TECHNICAL INFORMATION

Washing machines and dryers

4-023-1231

MODIFICATION ON CONTROL UNIT - DIFFERENT IONIZER CONNECTION

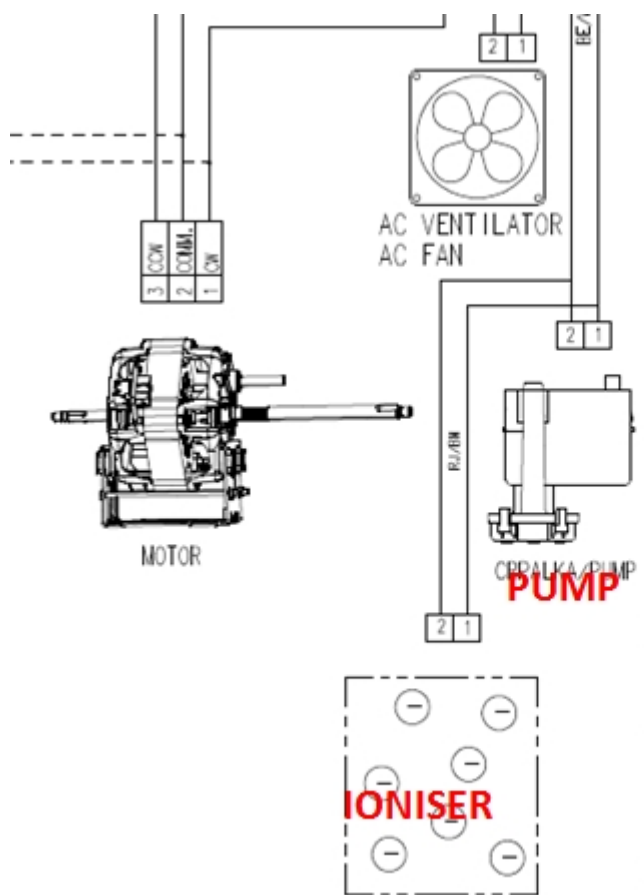
Removed connector from the main board - different ionizer connection.

Control unit before changes.

Control unit after changes - removed connector for ionizer and steam generator.

Removed connector (for ionizer and steam generator) from the main board. - different ionizer connection.

Ionizer is powered by the pump, it is necessary to replace the pump wiring set.

Old wiring set for the pump and the ionizer is eliminated.

For teh control units:

- 345074,
- 389536,
- 367228,
- 348914,
- 393532,
- 391783,

replace cable set 334656 and install 393294.

And eliminate cable set for the ionizer code 347600.

Connect the ionizer through the pump.
